VIRGINIA ELECTRIC AND POWER COMPANY
SURRY POWER STATION UNITS 1 AND 2
PROPOSED TECHNICAL SPECIFICATIONS CHANGE
BURIED FUEL OIL STORAGE TANK INSPECTION AND RELATED REPAIR
REQUEST FOR ADDITIONAL INFORMATION

**Response to NRC Request for Additional Information -
Proposed Technical Specifications Change Request
Buried Fuel Oil Storage Tank Inspection/Repair**

**Surry Power Station Units 1 and 2
Virginia Electric and Power Company
(Dominion)**

FIGURE 1 – TIME LINE

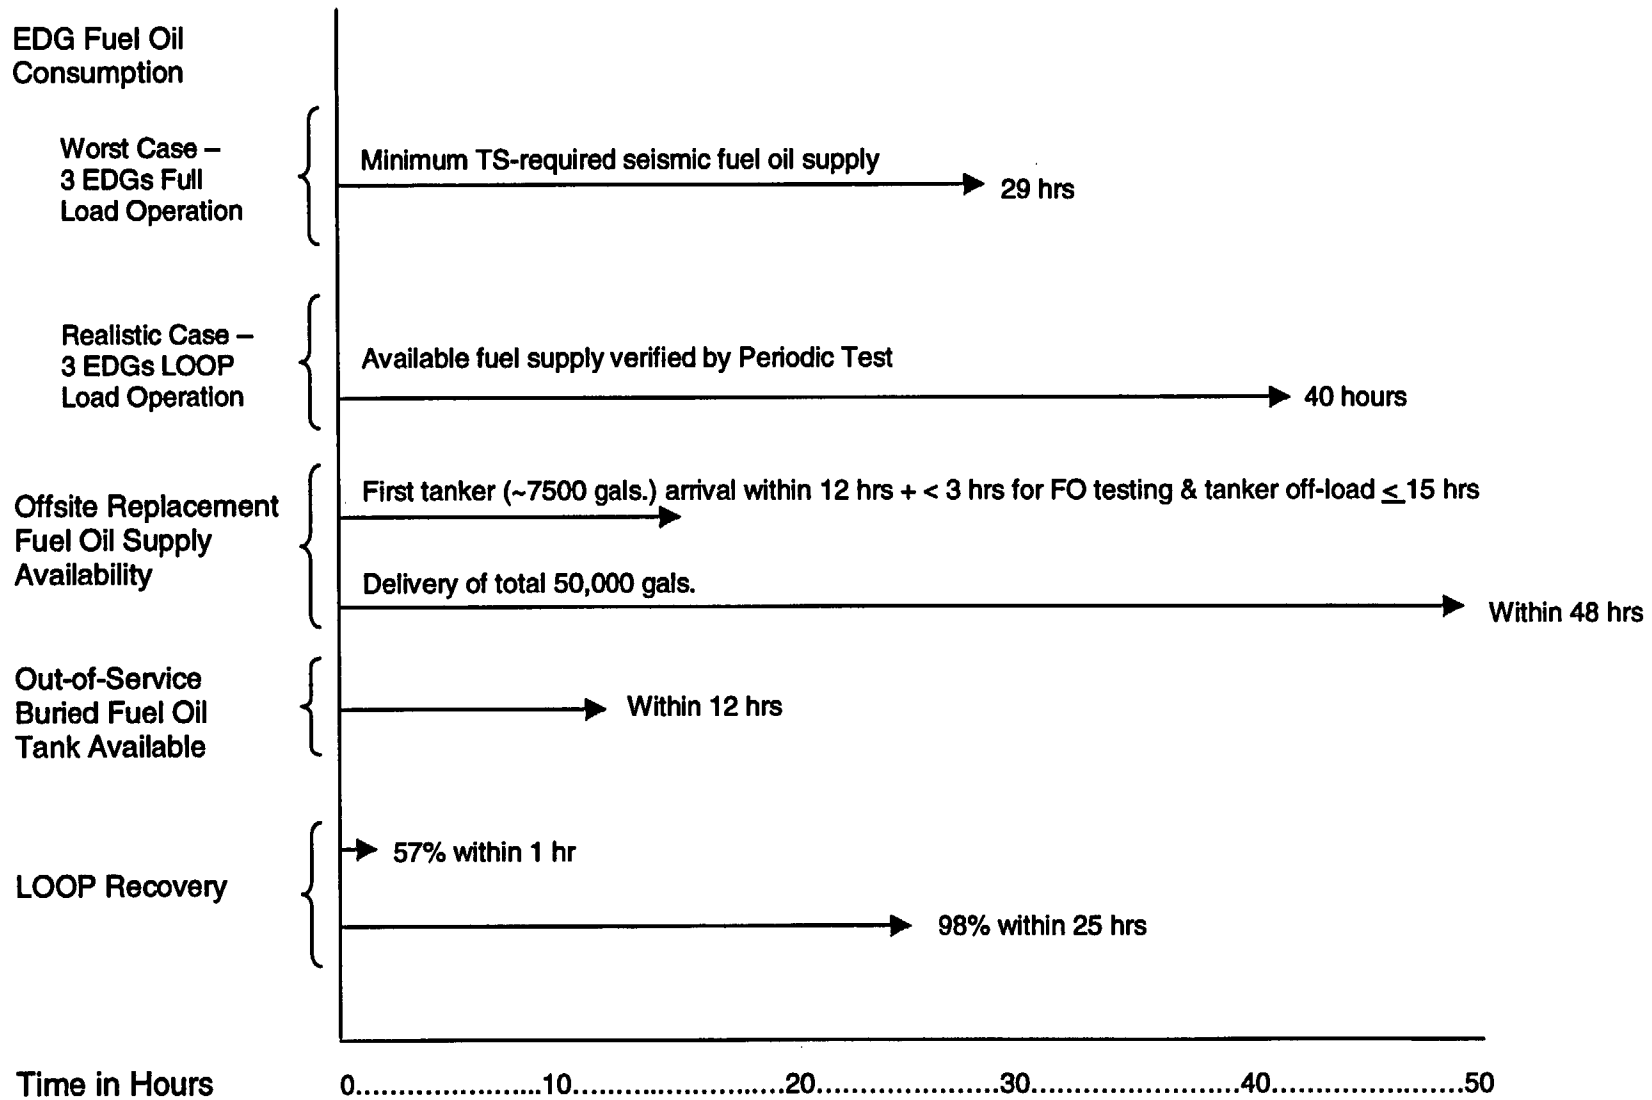
- 1. The information that was requested in Q3 is critical in determining how much time is available for the licensee to obtain off-site fuel oil and refill the only remaining safety-related, seismic, Category 1 storage tank before the 17,500 gallons is depleted. Therefore a more complete response to the specific question that was asked is required in order to judge whether or not a 48 hour delivery contingency is appropriate for their specific situation. I only consider 17,500 gallons of fuel oil to be available because it is the only seismic, Category 1, safety-related source of fuel oil. The other sources that are discussed are good to know about, but they cannot be relied upon for the worst case scenarios that must be considered. The licensee needs to determine how much time they have available for getting more fuel oil to the site (including how much time is needed to begin filling the tank), and this is the time that should be proposed in the submittal (48 hours may not be appropriate).*

The following discussion demonstrates that the proposed TS change, along with clarifying committed actions contained in this letter, ensures the availability of sufficient fuel oil to support EDG operation. Figure 1 presents the key elements of the time line, which are discussed in the following paragraphs.

With one buried fuel oil tank taken out of service for inspection, the following TS-required seismic fuel oil sources will be available. The proposed TS 3.16.B.4.b requires $\geq 17,500$ gallons in the in-service buried fuel oil tank. In addition, the existing TS 3.16.A.1 requires at least 290 gallons of fuel in each EDG's day tank. In the event that emergency power is required, the three EDGs will auto-start and run. For the purposes of addressing the worst case event, full load operation and the associated fuel consumption for the three EDGs is assumed. The minimum TS-required seismic fuel oil volumes will support approximately 29 hours of three EDG full load operation.

In addition to this worst case event, a more realistic event can be defined as one in which the available fuel oil in the seismic tanks is considered, along with estimated EDG loss of offsite power (LOOP) loads and associated fuel consumption for the three EDGs. In this case, the periodic test conducted once a shift verifies a buried fuel oil tank level of 18,000 gallons and a day tank level of 750 gallons for each of the EDGs. This available fuel oil supply will support approximately 40 hours of three EDG LOOP load operation.

Prior to removing a buried fuel oil tank from service for inspection, the proposed TS 3.16.B.4.a requires verification of availability of 50,000 gallons of replacement fuel oil offsite and transportation to deliver that volume of fuel oil within 48 hours. This verification is accomplished by contact from the station with Dominion's Oil Operations and Supply group located at Dominion's Innsbrook Technical Center. If needed, this fuel oil would be delivered by seven tanker trucks each carrying approximately 7,500 gallons from a terminal in Richmond, VA. The fuel oil carried by each tanker truck will support approximately 12 hours of three EDG full load operation (or 15 hours of three EDG LOOP load operation). Upon identification of the need for the offsite replacement fuel oil, the Oil Operations

and Supply group would be contacted a second time to initiate the delivery. Arrival of the first tanker truck onsite will be within 12 hours following notification of need. This delivery time commitment will be specified in the implementing procedure(s) for the buried fuel oil tank inspection activities. Upon arrival of a tanker truck onsite, necessary fuel oil testing for immediate acceptance criteria and tanker off-load could be completed within 3 hours (i.e., completion of testing within 2 hours and gravity feed to the buried fuel oil tank within 1 hour). Thus, the initial delivery of fuel oil would be available for use within 15 hours, and the delivery of the total 50,000 gallons will be complete within 48 hours as required by the proposed TS 3.16.B.4.a.

As noted in our April 16, 2003 letter, it is anticipated that the out-of-service buried fuel oil tank could be refilled and available within 12 hours. This 12-hour time frame assumes up to 8 hours to complete the activities identified in our letter, up to 2 hours to gravity fill the buried fuel oil tank from the above ground fuel oil storage tank, and an additional two hours for conservatism. In the event that the above ground tank is not available, the fuel oil from a tanker truck would be gravity fed to the buried fuel oil tank.

Another key consideration in the worst case event is the time for recovery of a LOOP event. Based on documented historical data through the year 1999, 57% of LOOP events are recovered within 1 hour and 98% are recovered within 25 hours, which is less than the worst case fuel depletion time of approximately 29 hours. This focus on a LOOP event is appropriate since, as indicated in our April 16, 2003 letter, the occurrence of earthquake or LOCA concurrent with a buried FO tank out of service is negligibly small ($6E-8$ /year and $1.8E-8$ /year, respectively), and concern with respect to a severe weather event is essentially eliminated based on either predictability of the occurrence or the ability to return the out-of-service tank to available status.
